PIC16F88X Family Silicon Errata and Data Sheet Clarification

The PIC16F88X family devices that you have received conform functionally to the current Device Data Sheet (DS41291G), except for the anomalies described in this document.

FIGURE 1: SCK PULSE VARIATION USING TIMER2/2

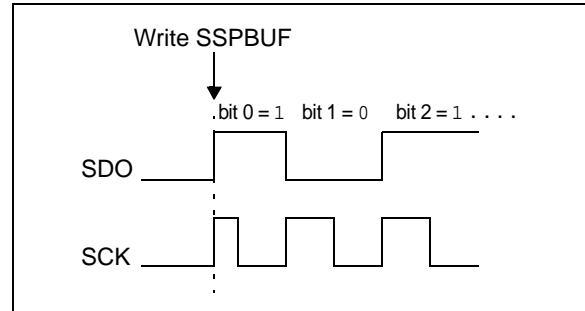
When the SPI is using Timer2/2 as the clock source, a shorter than expected SCK pulse may occur on the first bit of the transmitted/received data (Figure 1).

To avoid producing the short pulse, turn off Timer2 and clear the TMR2 register, load SSPBUF with the data to transmit and then turn Timer2 back on. Refer to Example 1 for sample code.

FIGURE 3: ACTUAL (INCORRECT) OPERATION WITH CLOCK STRETCHING – EXAMPLE 1

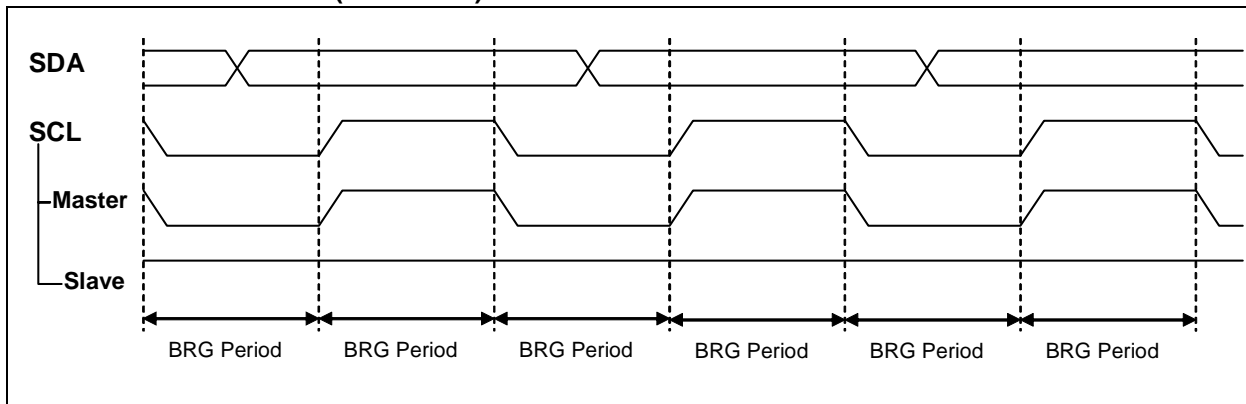
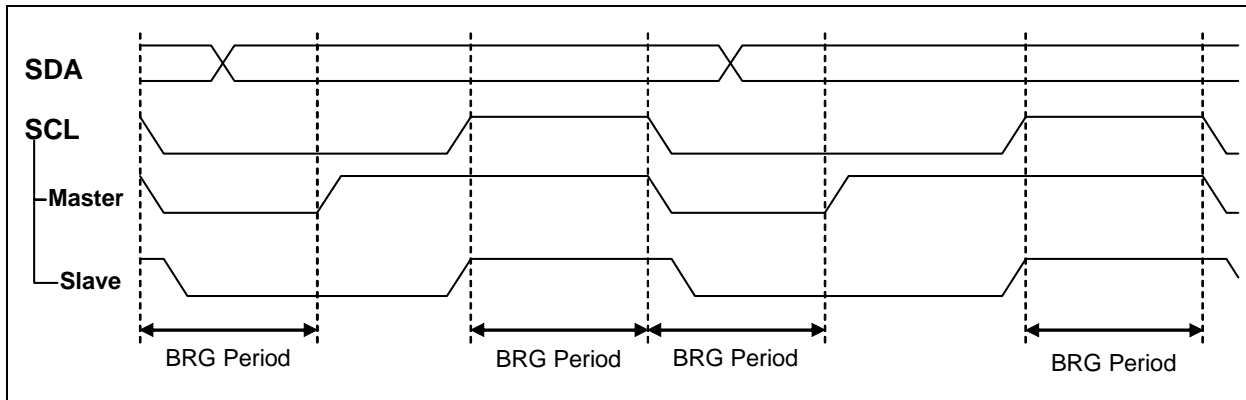
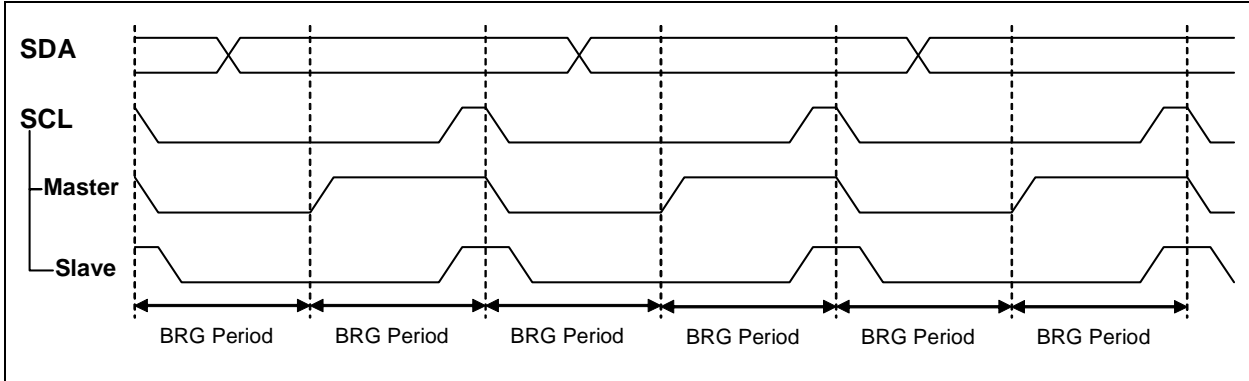
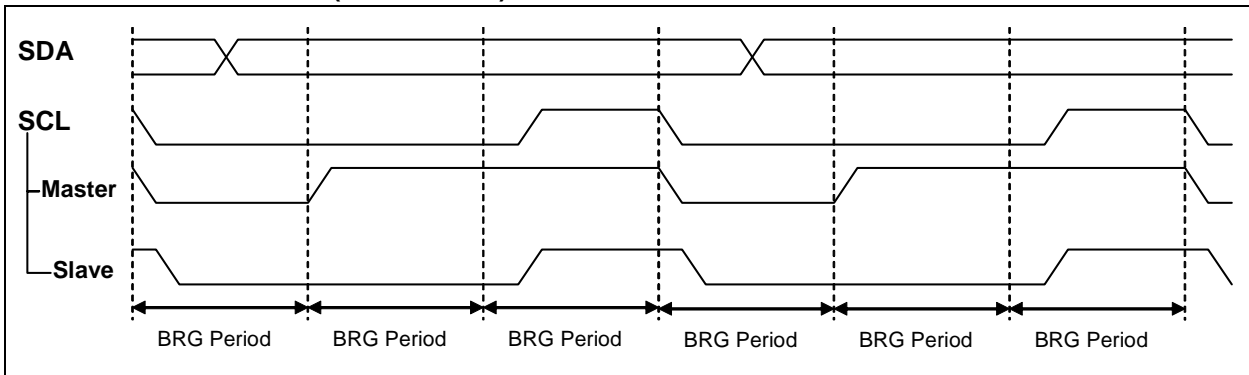
When the MSSP is I²C™ Master mode with a slave device stretching the clock, the clock generation does not function as described in the data sheet.

When a slave device is performing clock stretching by pulling the SCL line low, the master device should continuously sample the SCL line to determine when all slaves have released SCL. When SCL is released, the master device should wait one BRG period to ensure a constant SCL high time.

The current implementation does not ensure accurate SCL high time. During clock stretch, the MSSP device will erroneously continue running the BRG counter. At the end of the clock stretch, the BRG counter continues to count down for the

remainder of the BRG period, and then the MSSP device will immediately resume transmitting the data.

Figure 1 illustrates an expected I²C transmission in which the SCL line is completely controlled by the master device and the slave device does not attempt to stretch the clock period.

Figure 2 illustrates the expected operation of an I²C transmission in which the slave device has stretched the clock period by holding the SCL line low. The high time of the SCL pulse is constant, regardless of the duration of the clock stretch.

Figure 3 and Figure 4 illustrate an actual I²C transmission in which the slave has stretched the clock period by holding the SCL line low. Note that the high time of the SCL signal has shortened from the expected time.

Set the communication speed to match the slowest device on the bus. This ensures that no slave device will perform clock stretching.

It is possible to dynamically adjust the communication speed to match the device being addressed by modifying the BRG register. However, the behavior of slower slave devices must be understood and speed adjustments made such that no slave performs clock stretching.
